**NSLPP MEETING HELD ON 04/12/2024****Attachments:**

**ADDRESS:** 1 Warung Street, McMahons Point**APPLICATION NO:** DA 85/2024**PROPOSAL:** Demolition of existing structures and erection of a new residential flat building and ancillary works**PLANS REF:**

**OWNER:** Highbury Warung Pty Ltd**APPLICANT:** Highbury Warung Pty Ltd**AUTHOR:** Report of Thomas Holman, Senior Assessment Officer**DATE OF REPORT:** 24 October 2024**DATE LODGED:** 17 April 2024**DATE AMENDED:** 19 September 2024**RECOMMENDATION:** Refusal

LG: NORTH SYDNEY	SHEET 1 OF 2		
SURVEYED	DRAWN	CHECKED	APPROVED
PB_MB_ABS	ABS/CL	PB	AF
SURVEY INSTRUCTION	SCALE	DATE OF SURVEY	
19099	1:100 @ AO	28/01/20-25/01/21	
DRAWING NAME	ISSUE		
19099Adetail	6		
CAD FILE			
19099Adetail 6.dwg

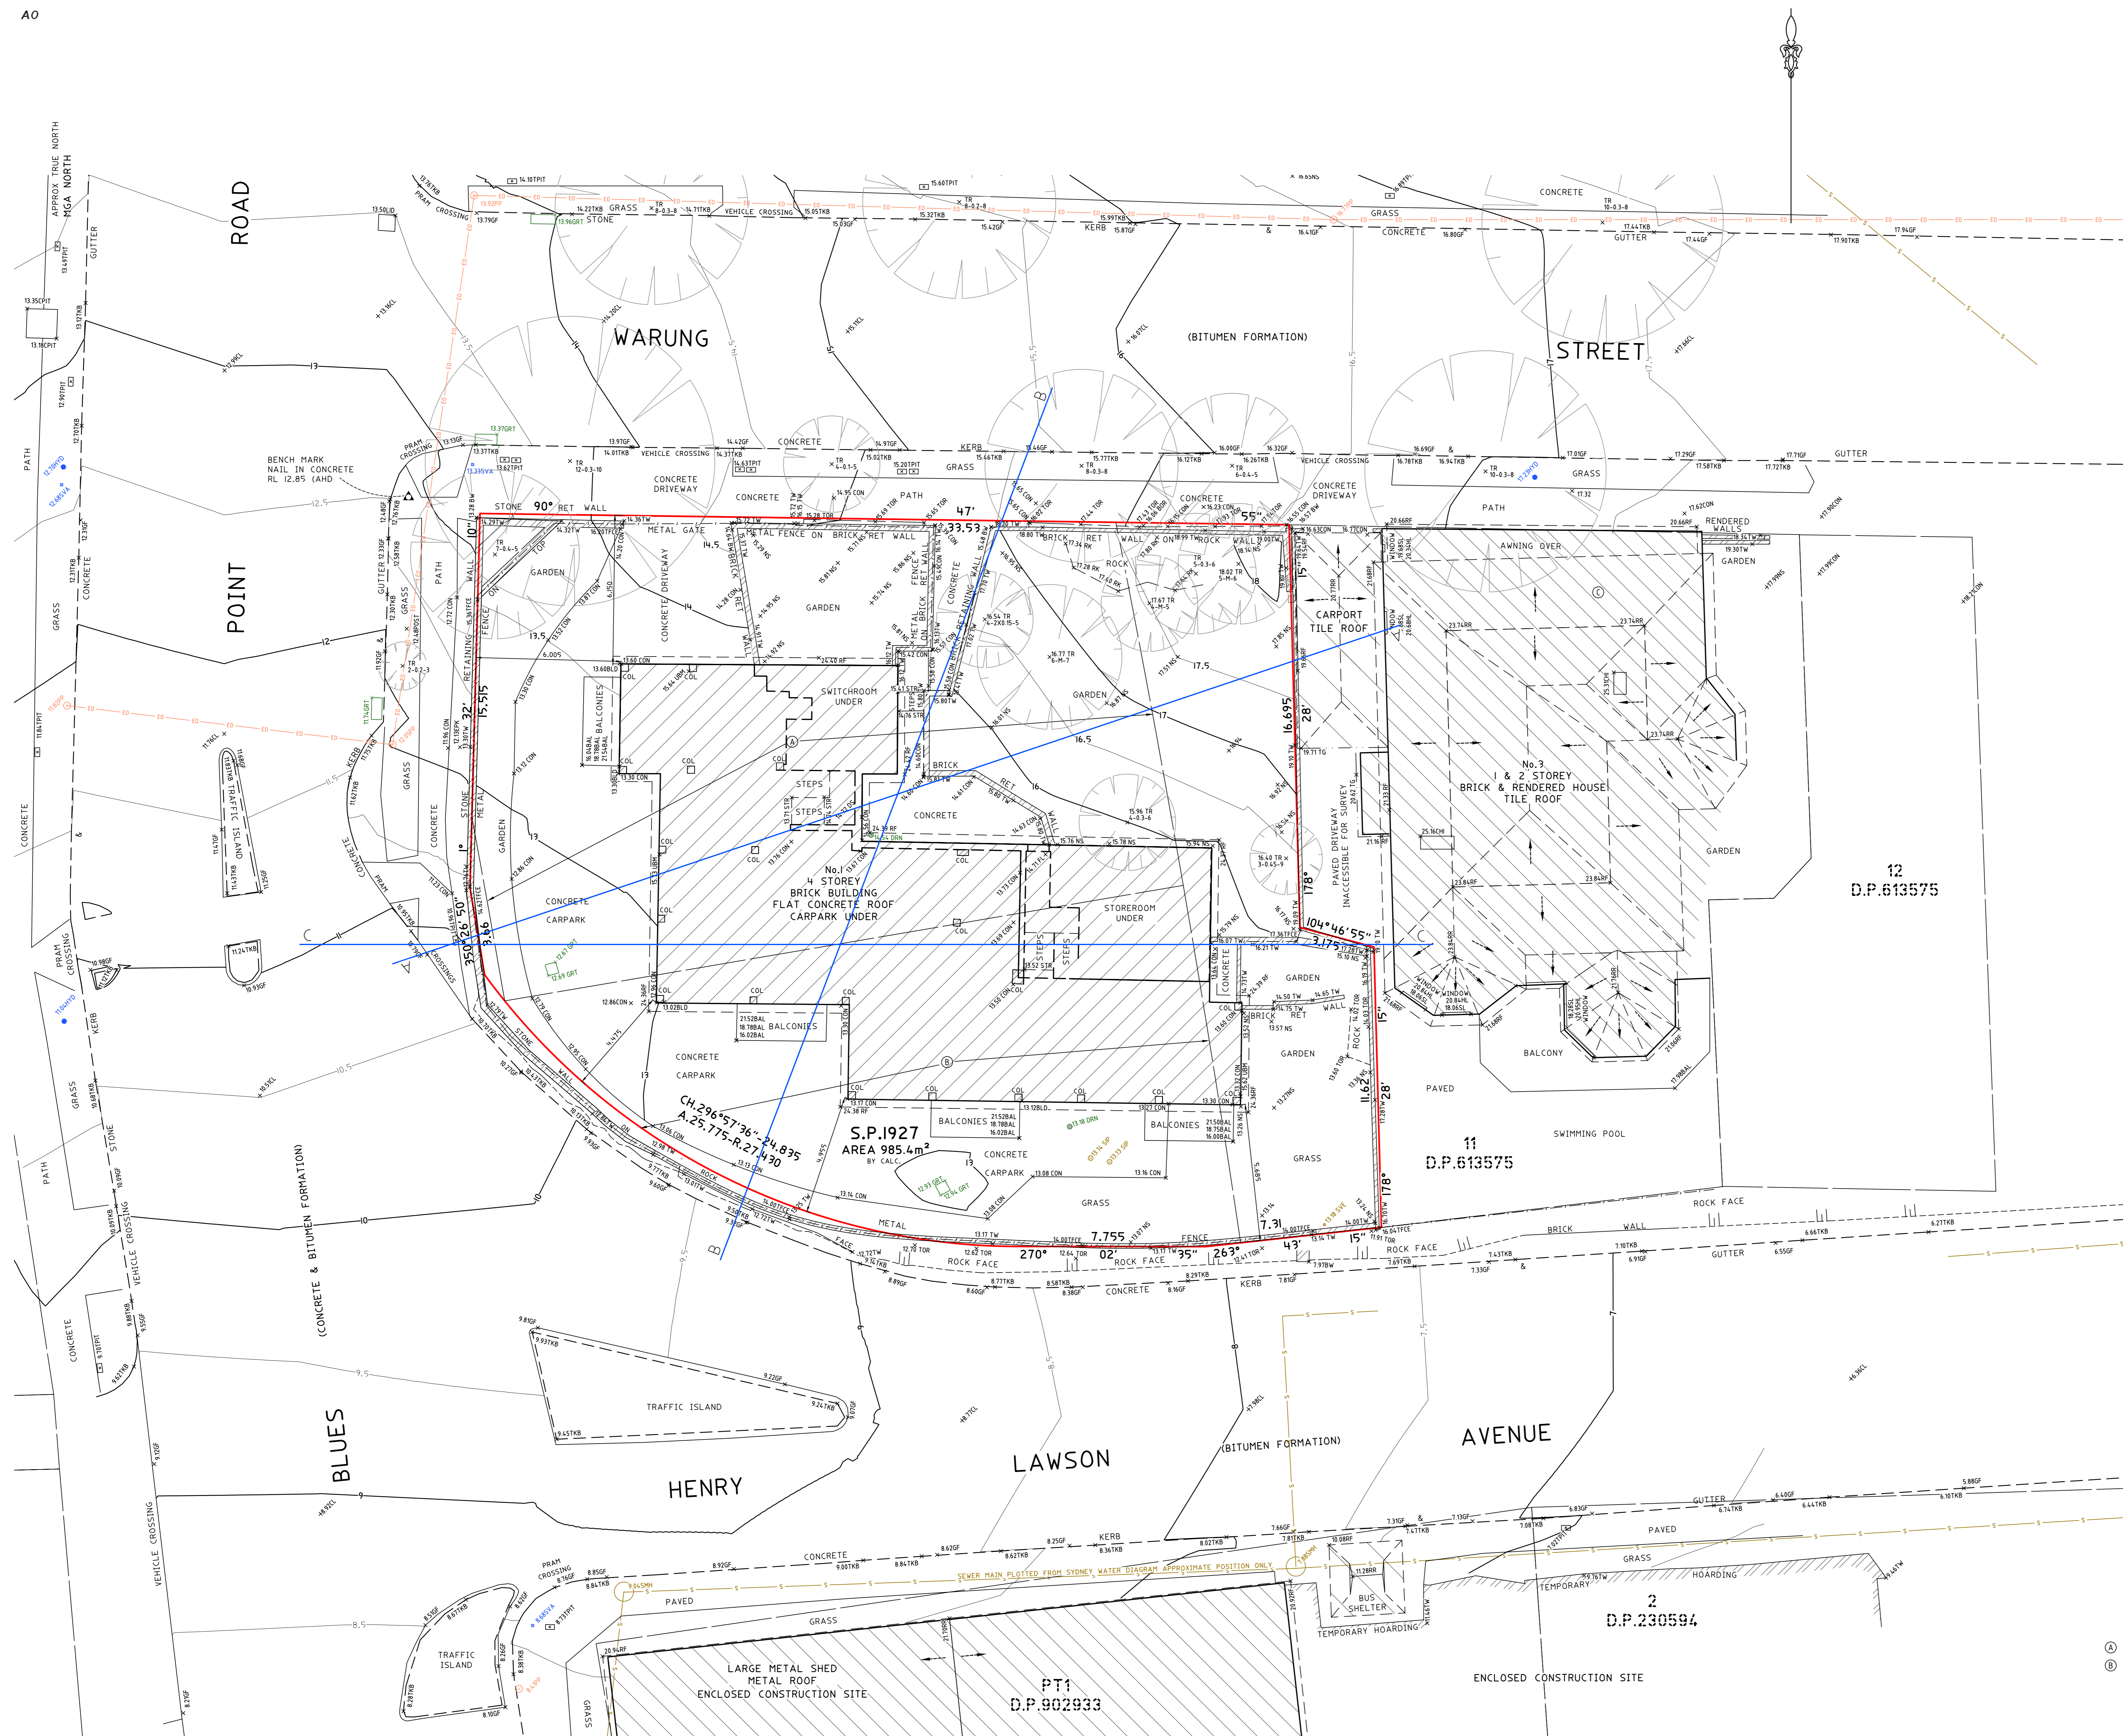
The proposed development does have an additional impact to the western elevation of No. 3 Warung Street casting additional shadow to various windows. The Assessment Officer visited the adjoining property to consider the amenity impact and noted main internal living areas are affected (kitchen and lounge room). It was also noted that the windows/ openings on the western elevation are not accurately shown as the western elevation has not been surveyed (refer to C.M.S Surveyors Dwg 19099A detail Issue 6).

- c) The proposed development does have an additional impact to the western elevation of No. 3 Warung Street casting additional shadow to various windows. It was also noted the windows/ openings on the western elevation are not accurately shown as the western elevation has not been surveyed (refer to C.M.S Surveyors Dwg 19099A detail Issue 6).
